Re: Approval of Application to Permit a Portion of Lease UTU-74804, Lodestar Energy Inc.,
Horizon Mine C/007/020-SR00B, Outgoing File

**UTAH DIVISION OF OIL, GAS AND MINING
STATE DECISION DOCUMENT AND
TECHNICAL ANALYSIS**

Lodestar Energy Inc.
HORIZON MINE
C/007/020
Carbon County, Utah
February 26, 2001

Figure 2
Cumulative Hydrologic Impact Assessment
Horizon Mine

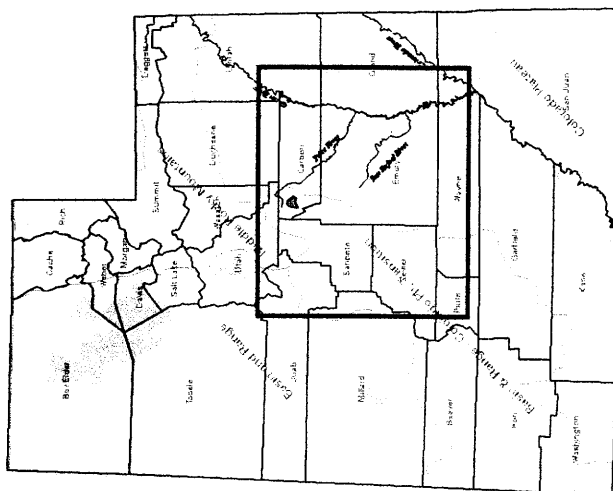
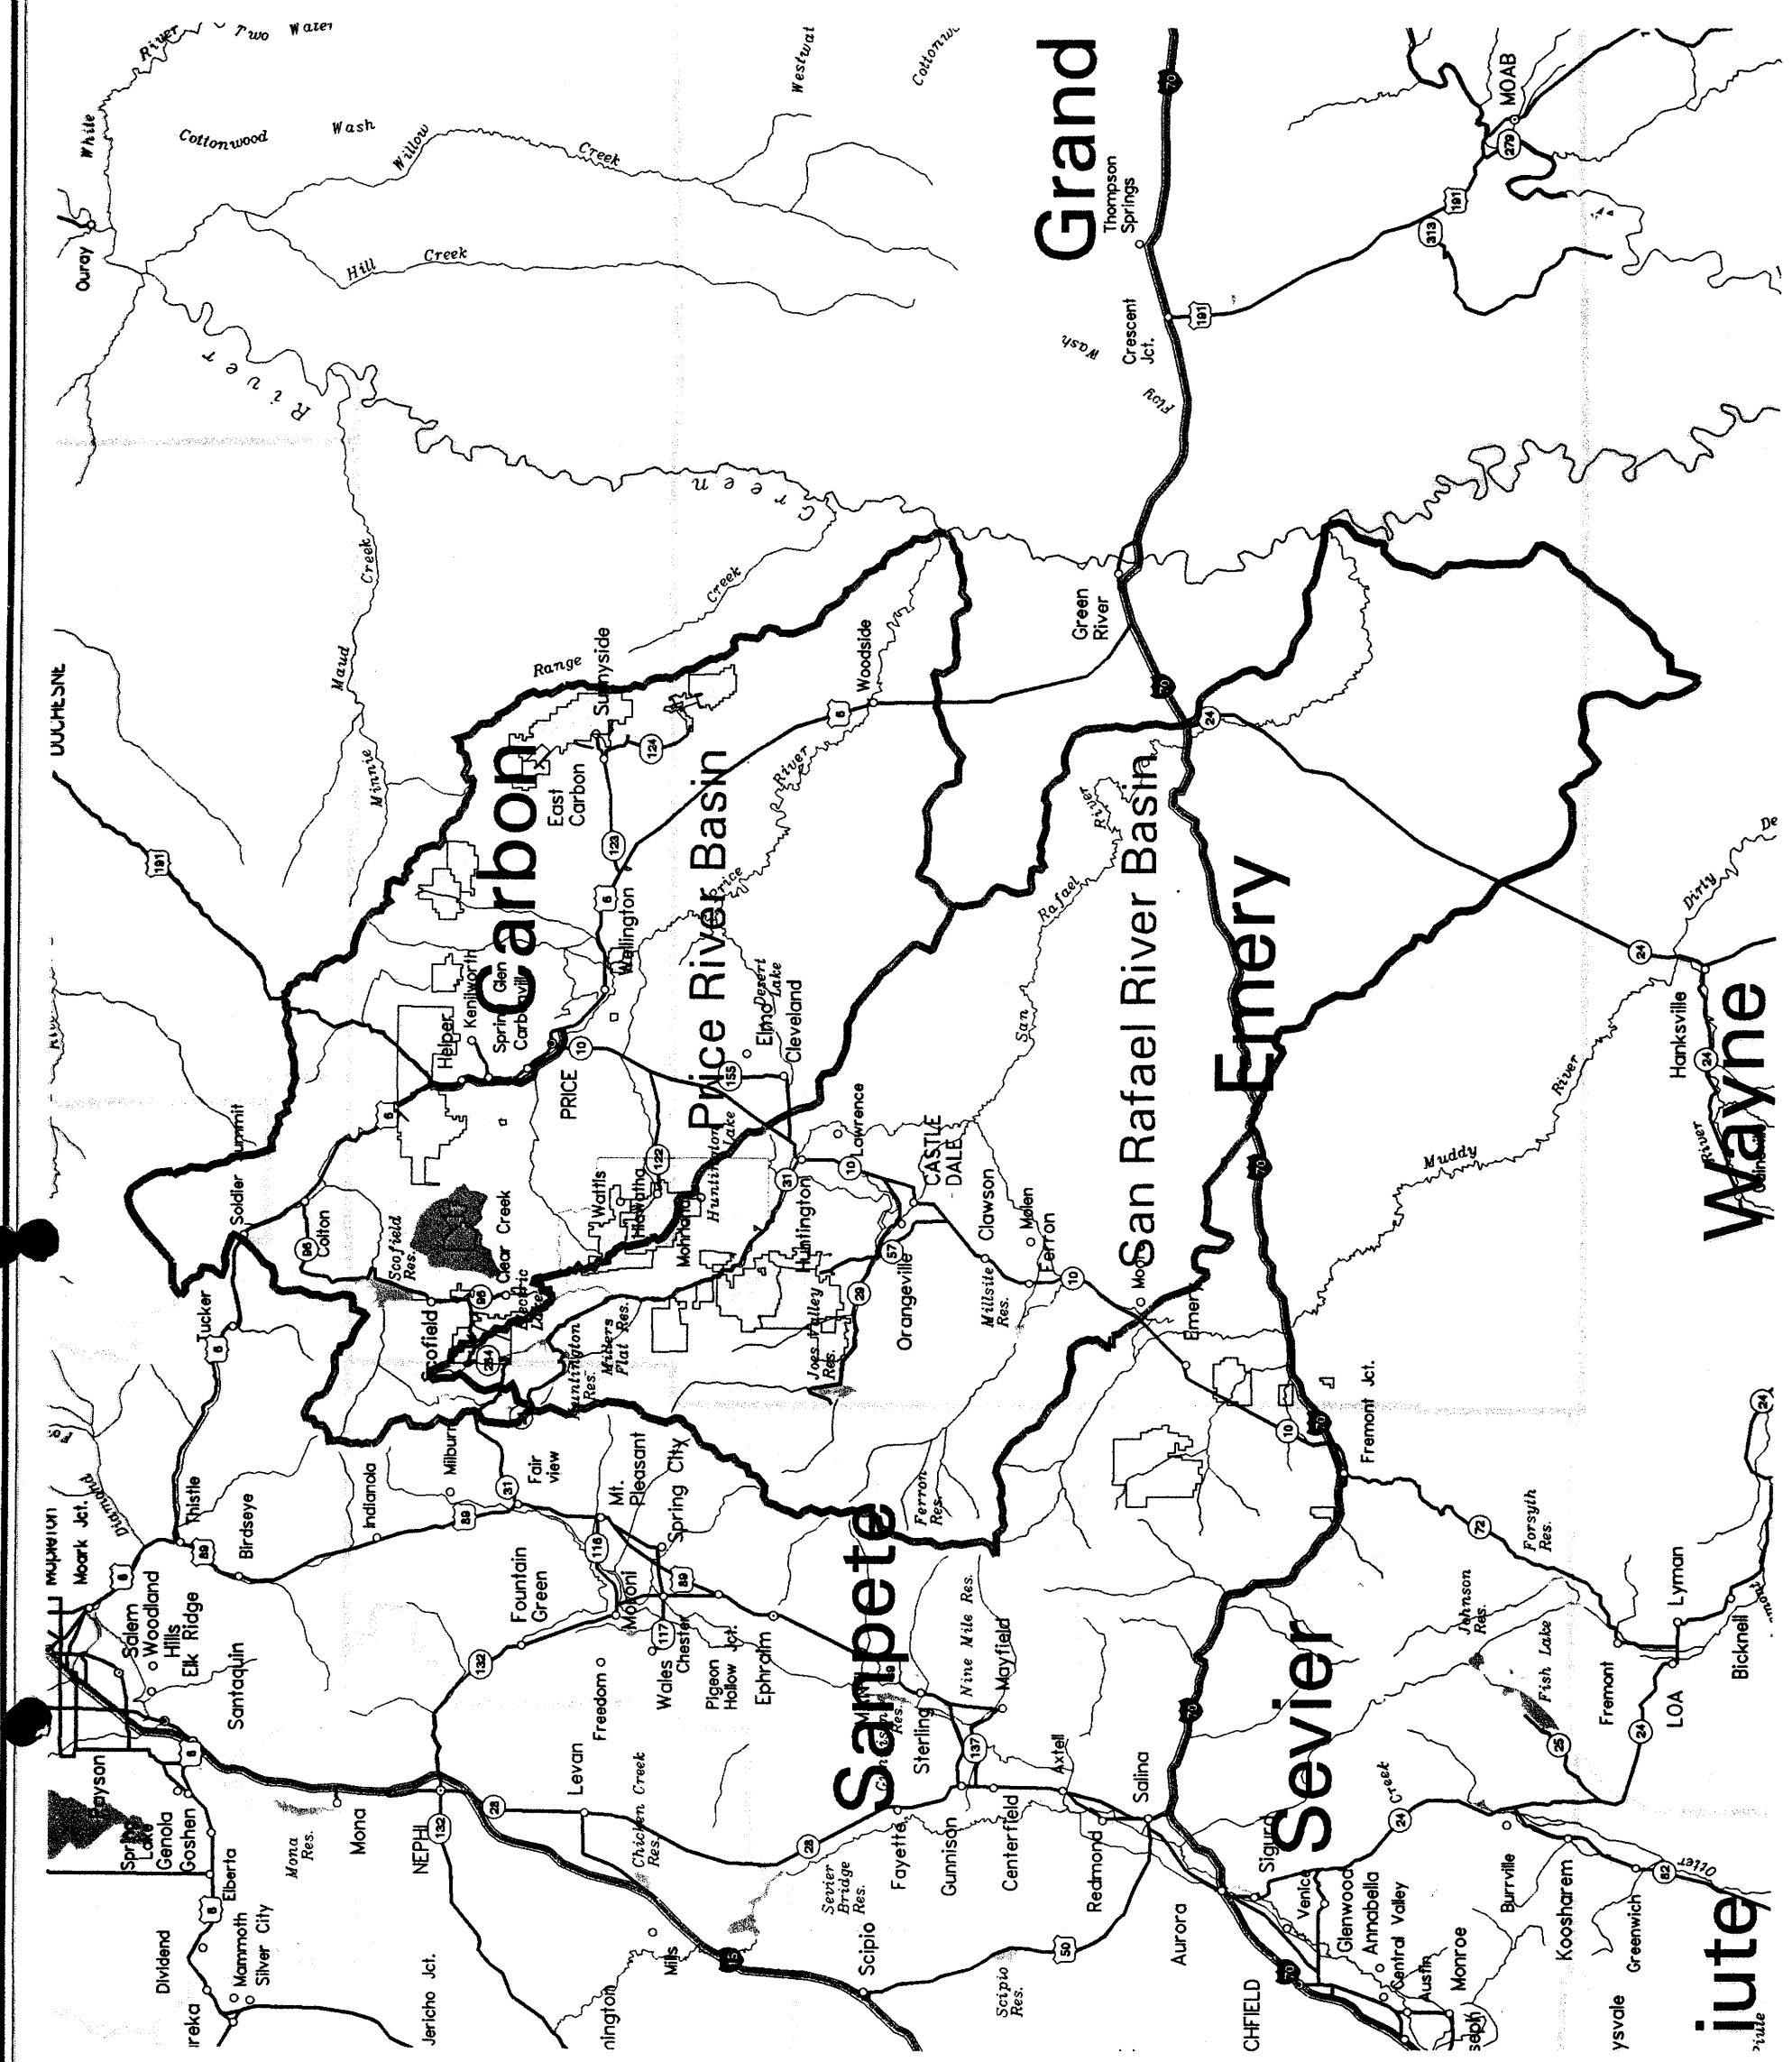
Horizon Mine is 14 miles due west of Helper, Utah (**Figure 2**). The mine portals are located in the Portal Canyon a north east trending side canyon of Consumers Canyon. Portal Canyon is an ephemeral drainage that joins Consumers Canyon. Jewkes Creek flows down Consumers Canyon and discharges to the North Fork of Gordon Creek.

Figure 4
Cumulative Hydrologic Impact Assessment
Horizon Mine

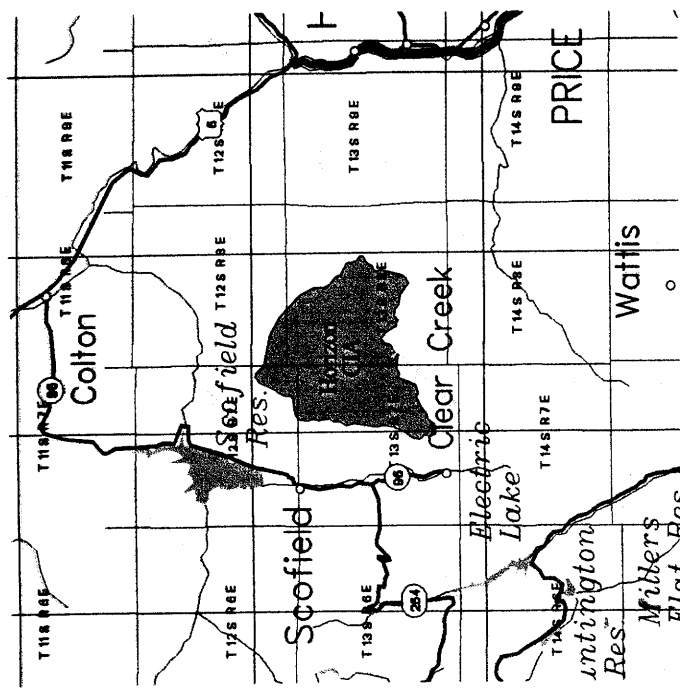
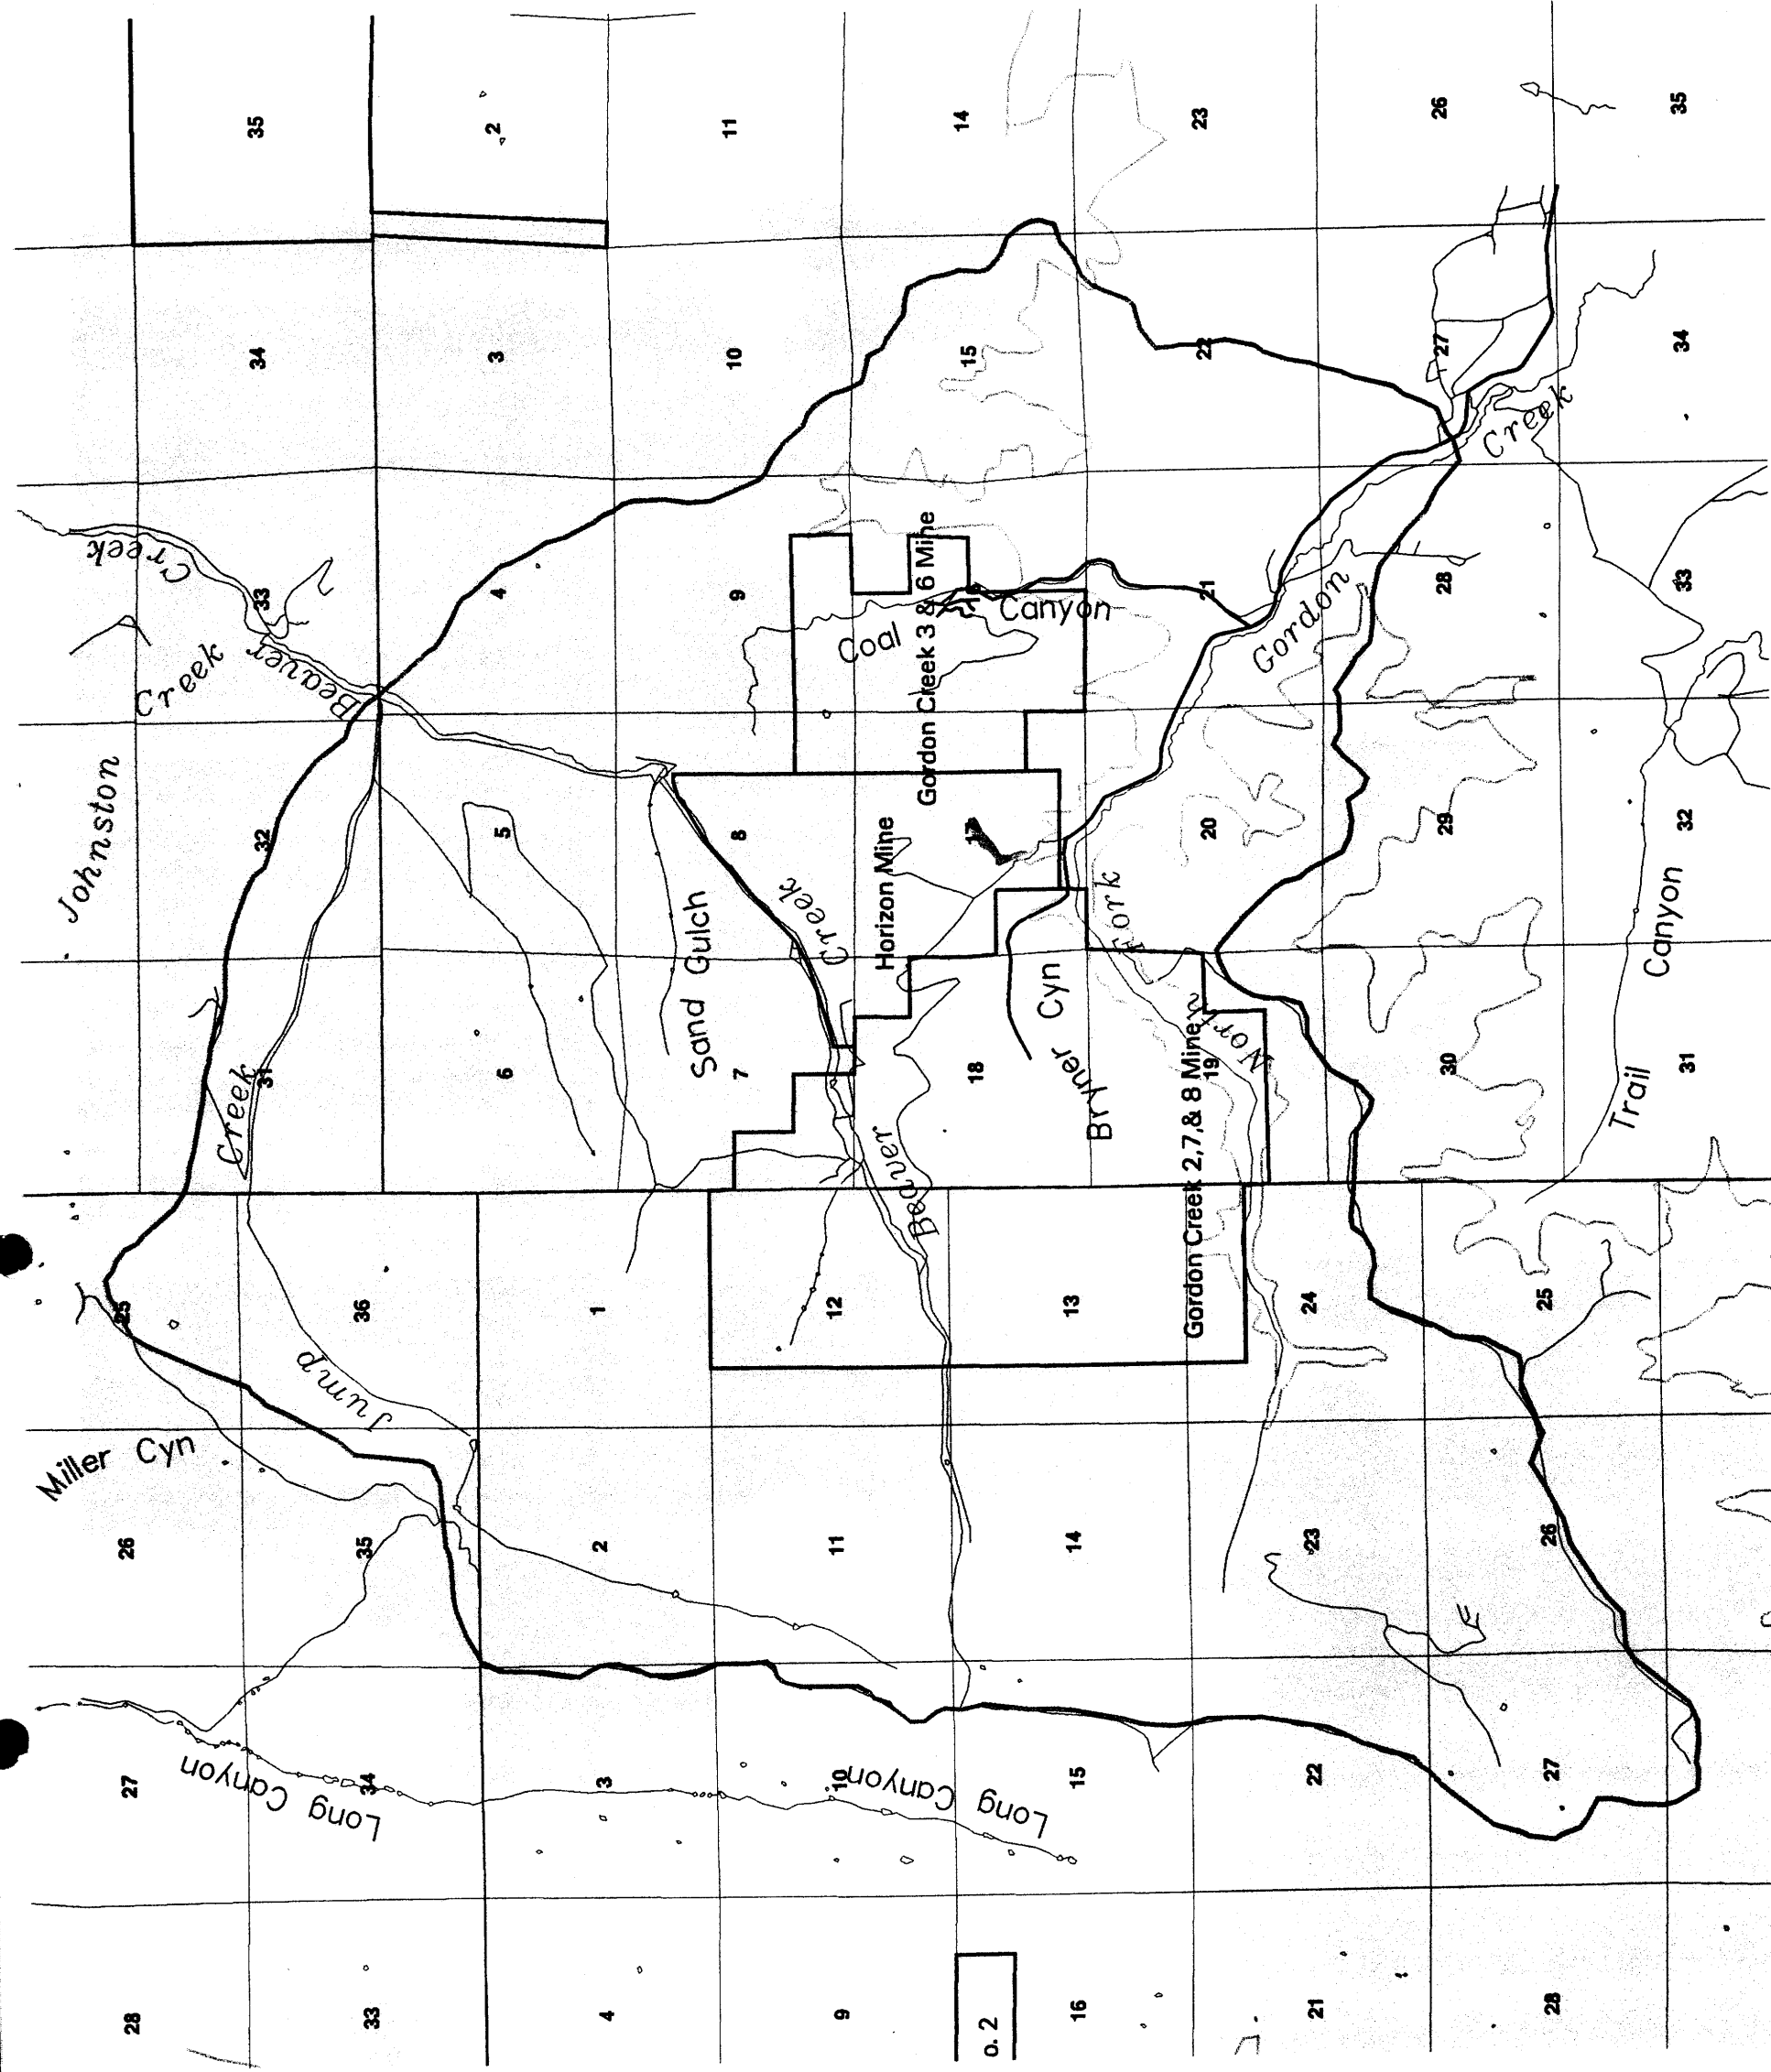
There are two coal seams of economic interest at present, **Figures 4 and 5**. These seams are the Castlegate A Seam, **Figure 4**, which lies above the Aberdeen Sandstone Member of the Blackhawk Formation and the Hiawatha Seam (Wattis, after Tabot 1999), **Figure 5**, sits directly on the Starpoint Sandstone. Recent, geologic evaluation of the coal seams by personnel of the Utah Geological Survey presents an updated nomenclature of the coal seams in the northern Wasatch Plateau.
